Re: 46 Sconticut Neck Road (Residence by Girls Creek)

Nesra Engineering LLC., (Nesra) is in receipt of the latest peer review from GCG associates. We would like to note that many of the comments provided in this round of peer review were already addressed in the last round. Please see our responses in green.

Re: Residence by the Girls Creek
Definitive Subdivision Plan, 46 Sconticut Neck Road, Fairhaven, MA.

DRAWING NO.: C-7

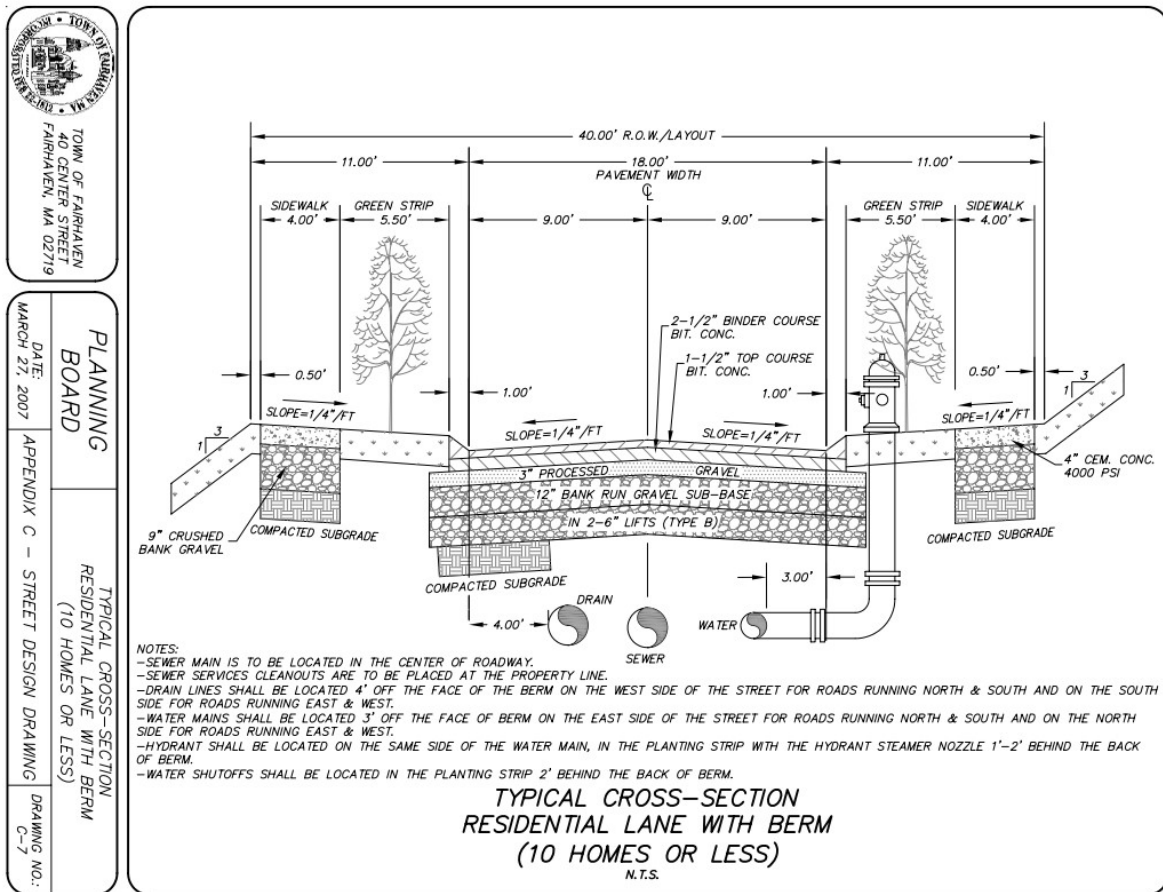
1. Water main and sewer line should have a minimum 10 feet horizontal separation. This is a new construction, there is no reason for having 6' separation as shown on the plan.

2. Although Appendix-C, Drawing C-7 shows water and sewer main with 6’ horizontal separation, MassDEP requires a minimum 10’ when possible. GCG recommends providing minimum 10’ separation between the two mains.

It was designed per town details. The sewer is called out to be at the center of the road while the water is to be 3-ft of the edge. With 9-ft lanes this only allows for 6-ft of separation.

It is designed by Appendix C Drawing C-7. There has been no mention of shifting them further apart through 3 rounds of peer review. The change would require updating all the plans. We are not opposed to it if it can be done by a note or a condition of approval.
